PROJECT ID NO. SWQ0000005

**MONTEITH PARK AND VIEW PARK
GREEN ALLEY STORMWATER IMPROVEMENTS**

NOTICE INVITING BIDS

- *Sheet DR-10 (sheet 10 of 70) – Revision 2*

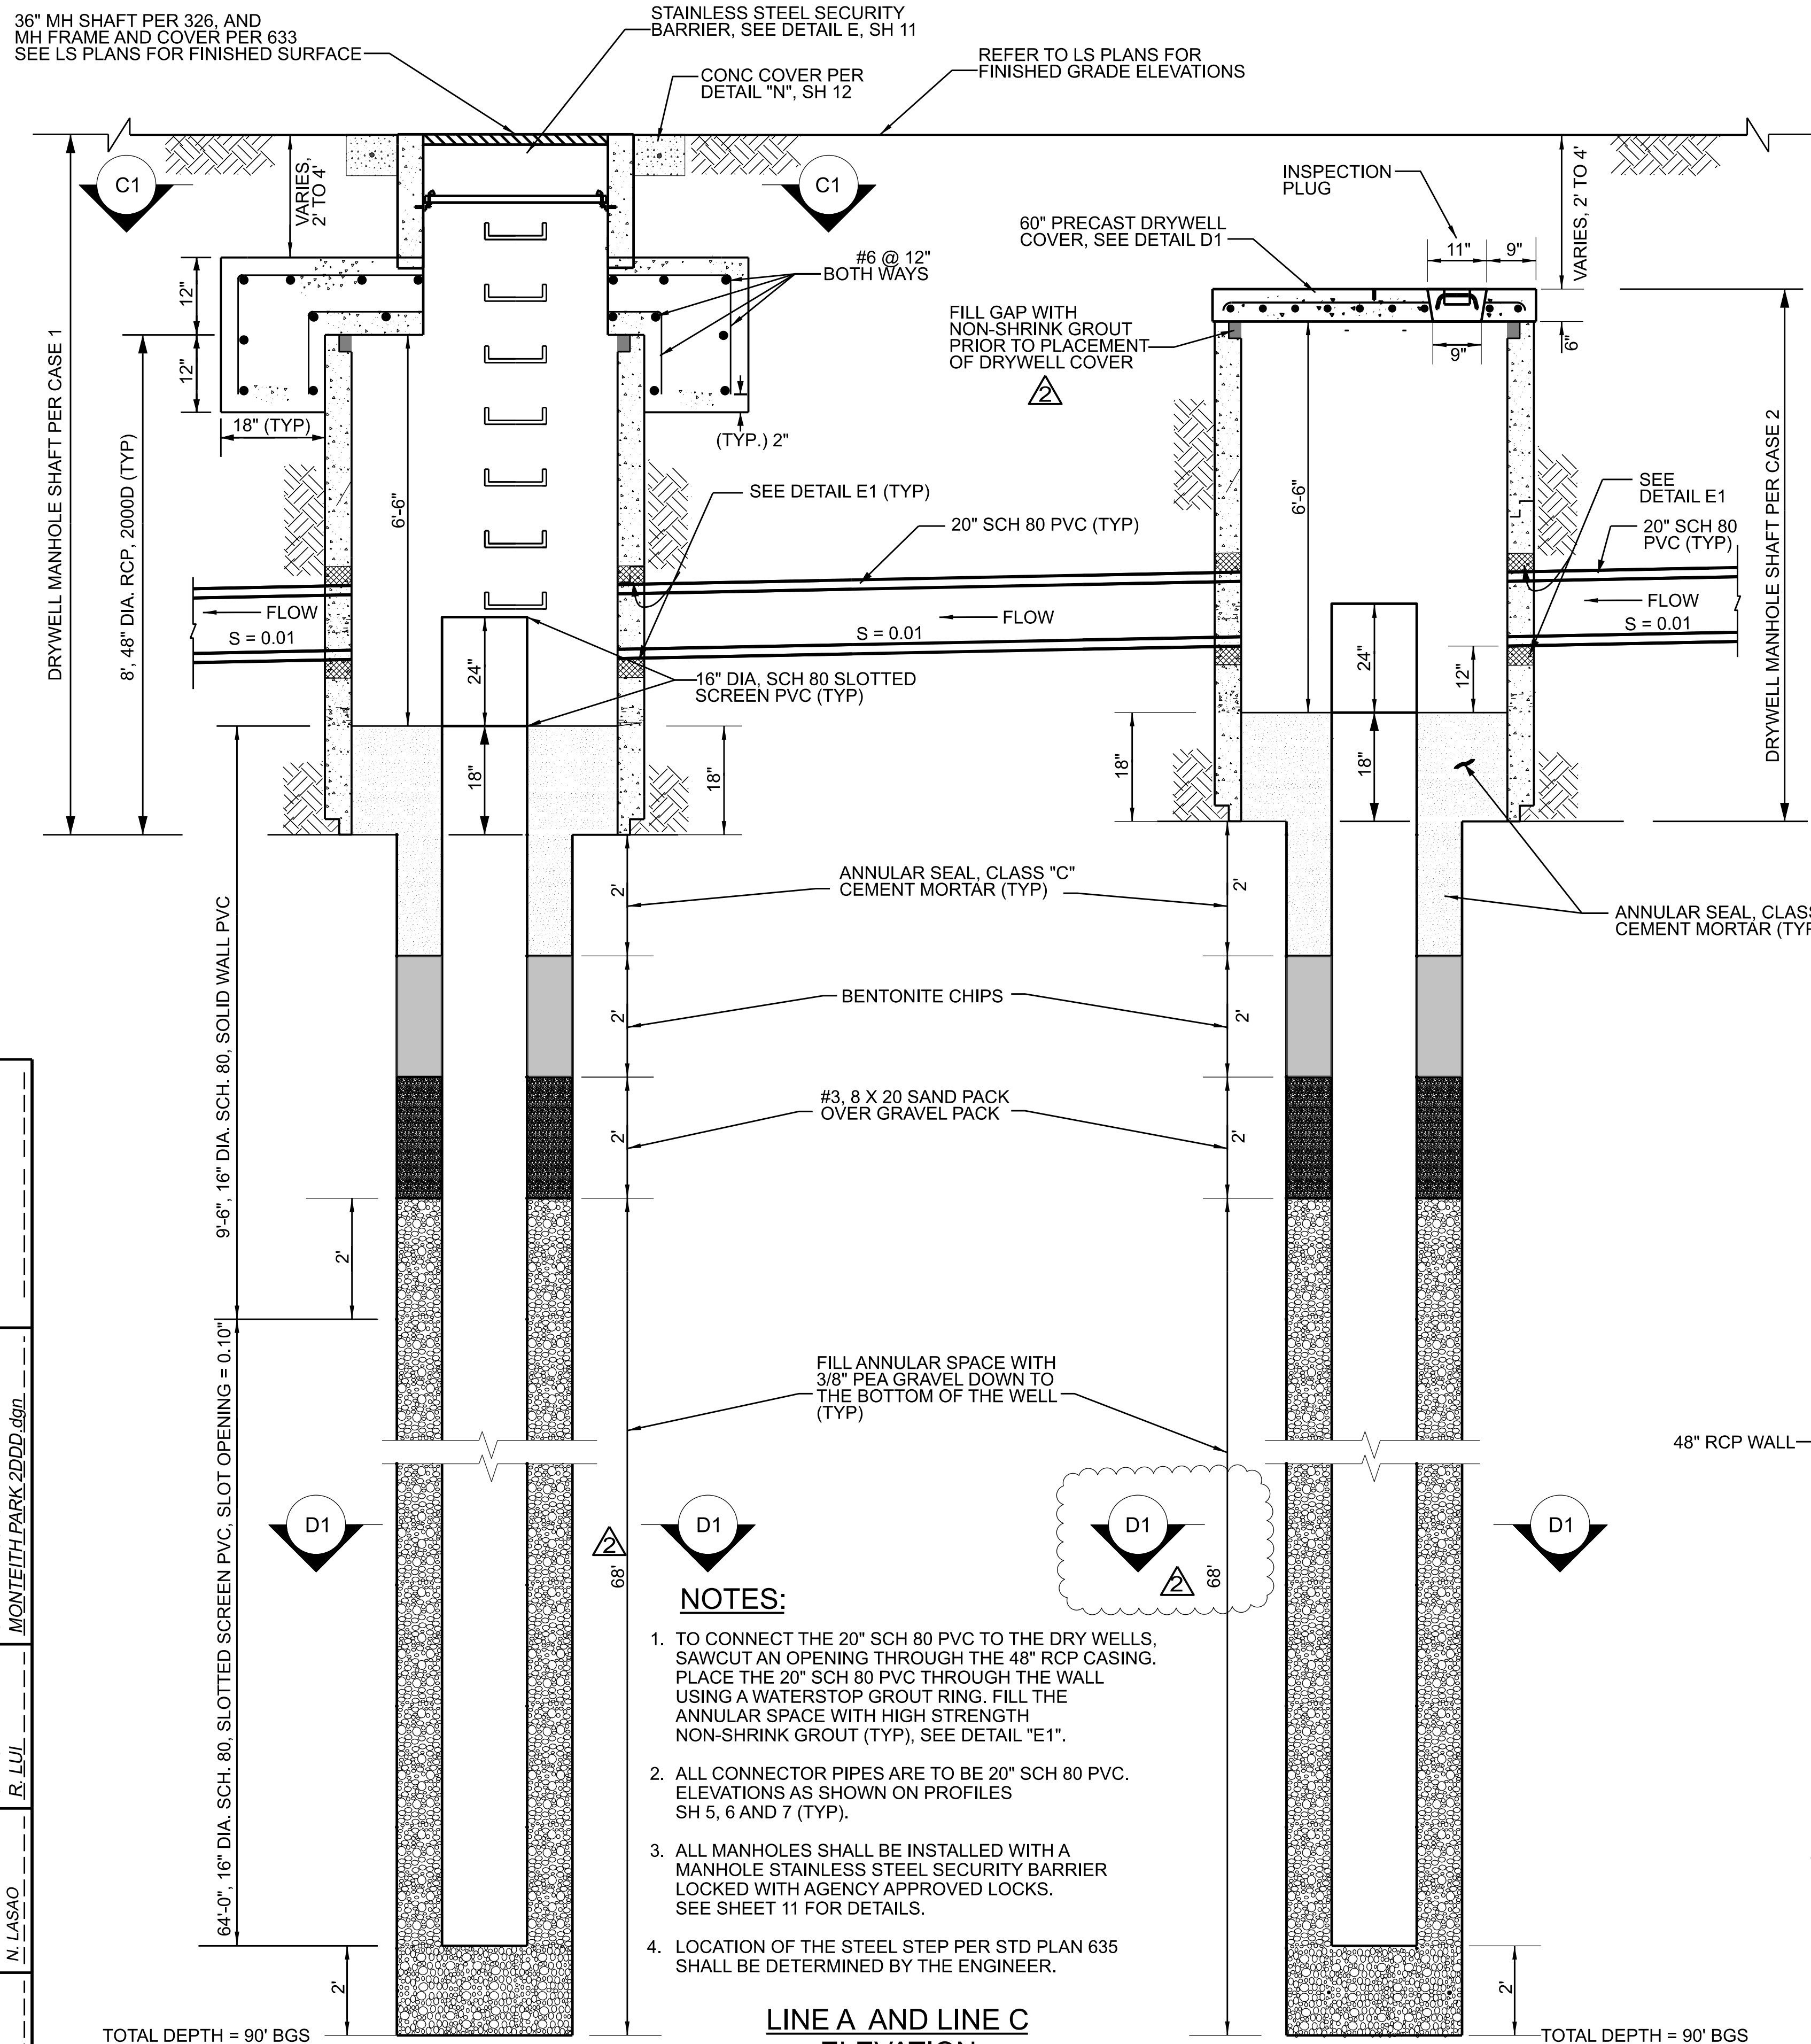
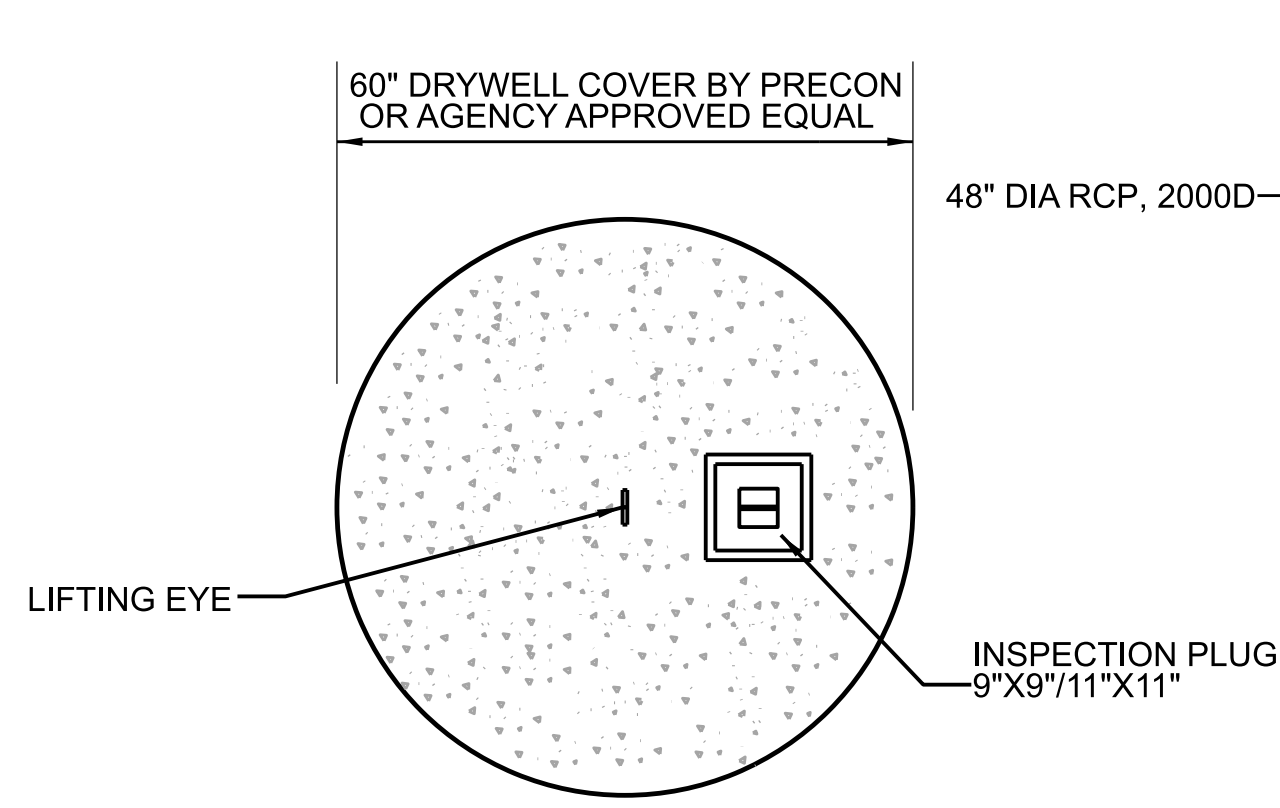
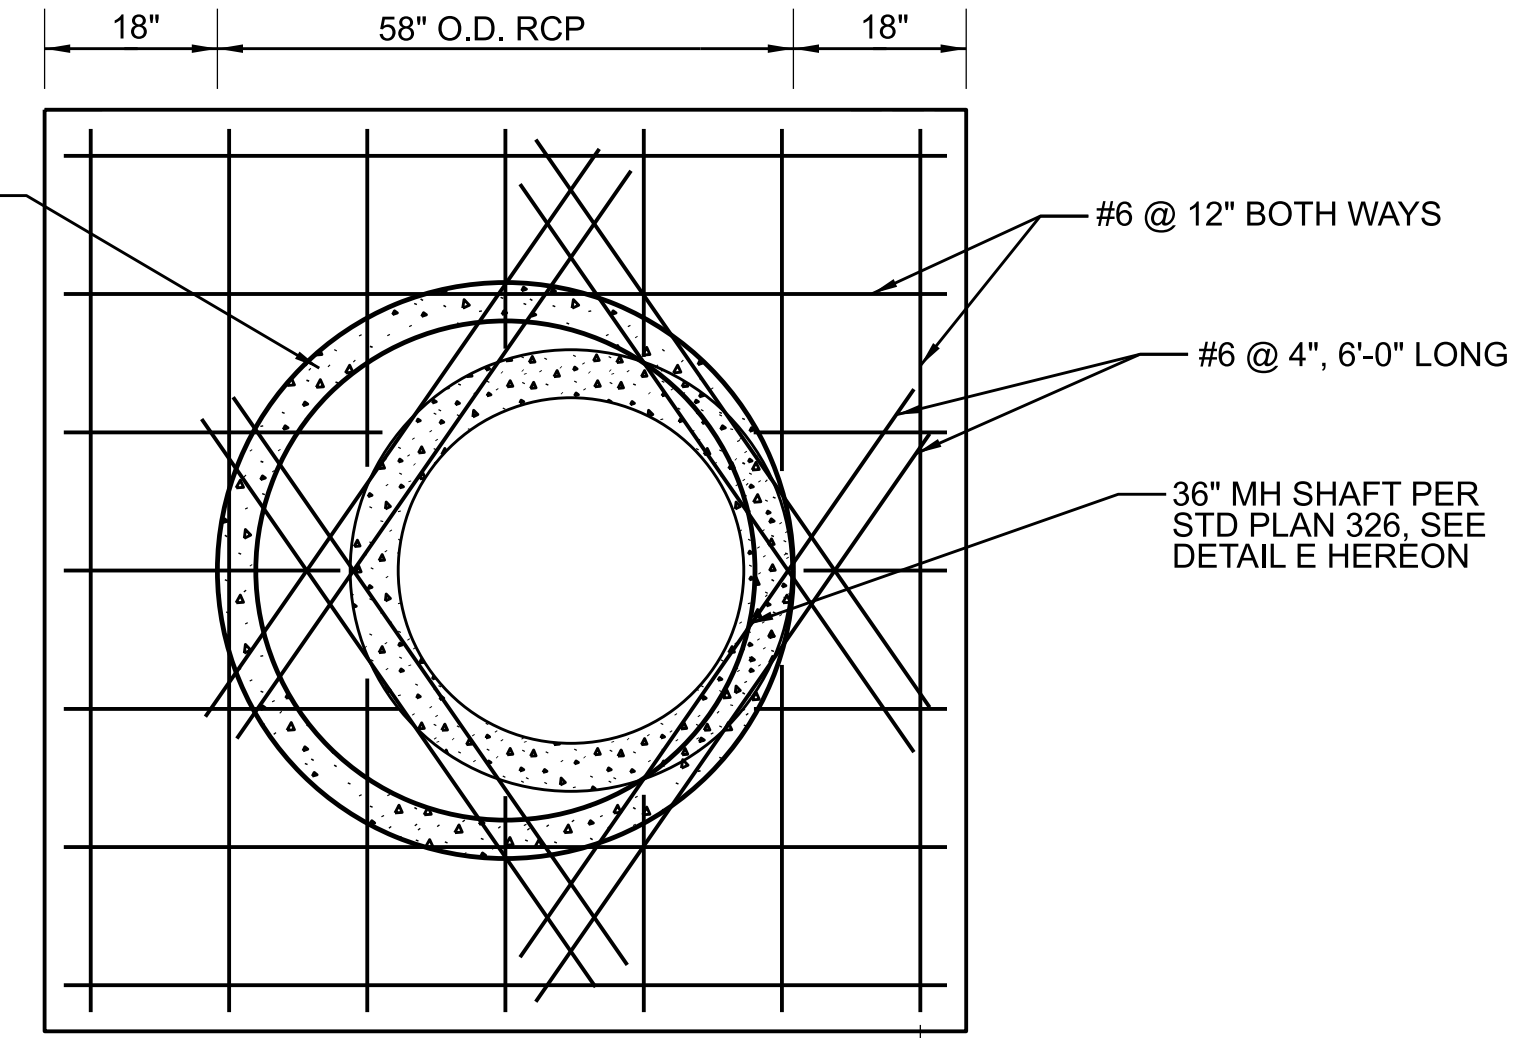
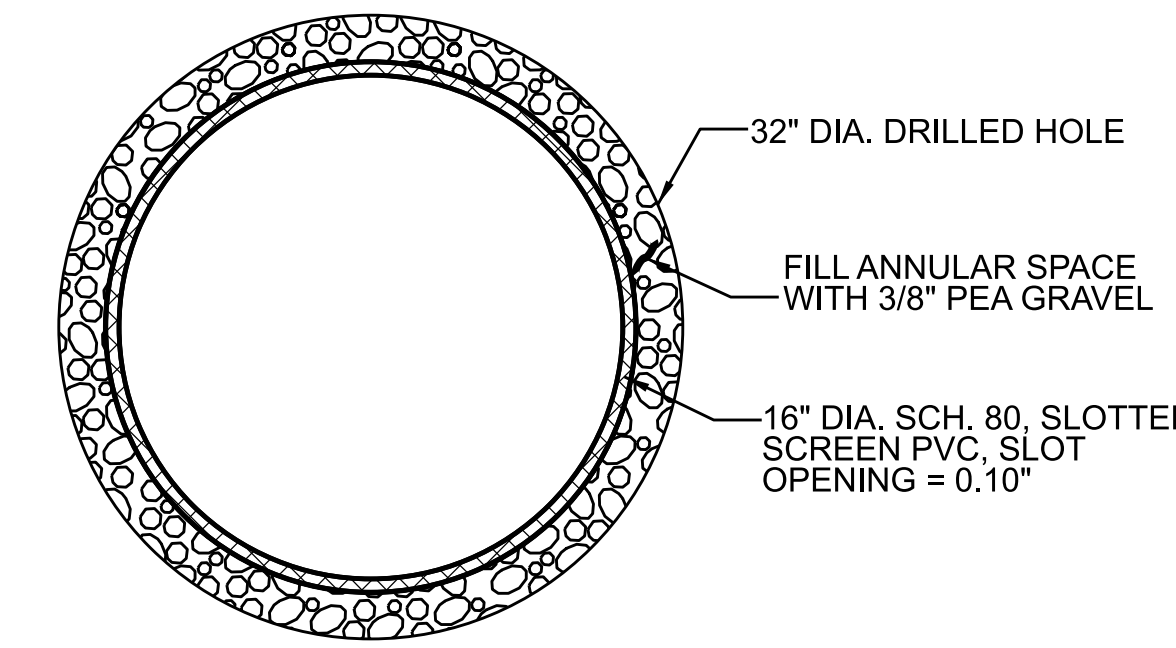
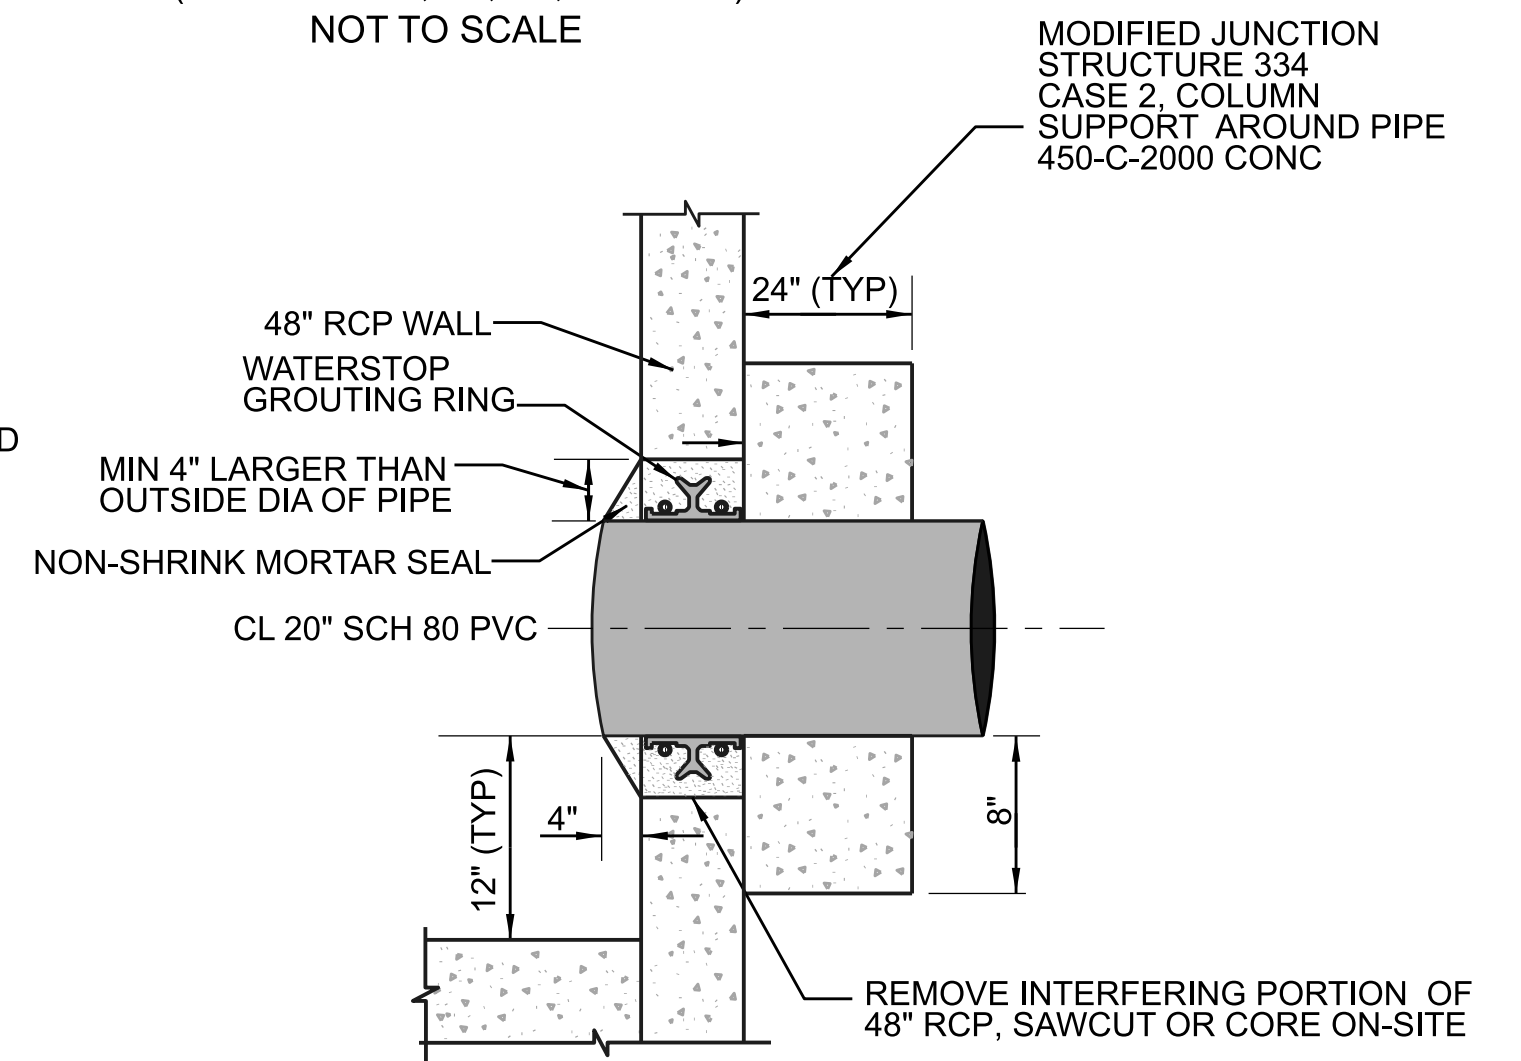
Q18. *The bottom dimension for the Case 1 drywell shown on drawing DR-10 is 78'. The dimension for the 16" Slotted Screen PVC is 64' plus 2' on the top and bottom. Please advise if the 78' dimension should be 68'?*

A18. The bottom dimension of 78 feet for the Case 1 drywell shown on Sheet DR-10 is revised to 68 feet. Refer to the revised Plan sheets included with this Addendum No. 2.
